File #	richalds) 1	0-E-22-VA		
CITY OF KNOXVILLE BO	ARD OF Z	ONING	APPEALS	APPLICA	TION
				38.9 8	
Please reach out to a City of Knoxville Zoning Exan	niner about voi	ur project be	efore submittin	a a variance a	nnlication
APPLICANT INFORMATION	APPLICAN1		THIS PROPOSA		
Name (Individual not company) Phillip Lopez		New St		Z I EKI AIN S	<b>O</b> .
Street Address 4208 Garden Dr.	Contractor [	<b>=</b>	ation of Existing	=	
City, State, Zip Knoxville. TN 37918	Tenant [	-, I	et Parking		
Phone Number 786-516-4007	Other [	Signage	_		
Applicant Email plworldwide8@amail.com		Other			
	S A REQUEST				
Zoning Variance (Building Permit Denied)			n-Conforming Us	e/or Structure	
Appeal of Administrative Official's Decision		p Interpretat	on		
	RTY INFORMA		City State Zin 7	TNI 27010	
Street Address 4208 Garden Dr. See KGIS.org for Parcel # 049PA052 City Counc			City, State, Zip and Zoning Distr		
	NCE REQUIREA		and Zoning Distr	ICC

10-E-22-VA PHILLIP LOPEZ

# Board of Zoning Appeals – City Staff Comments

#### 10-E-22-VA

# PROPOSED PLAN

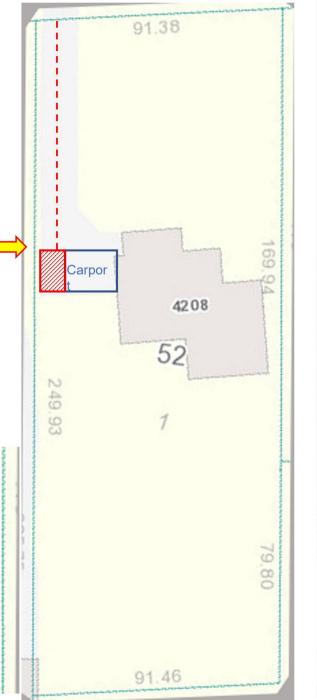
The setback requirements for a carport are 5 feet from interior side lot line. The column supports for the carport would be located on the driveway and obstruct parking vehicles. The applicant is requesting to reduce the interior side setback to 0 feet and place structures on the lot line.

Decrease the interior side setback for an accessory structure from five feet to zero feet to permit an attached carport. Per Article 10.3.A.5.
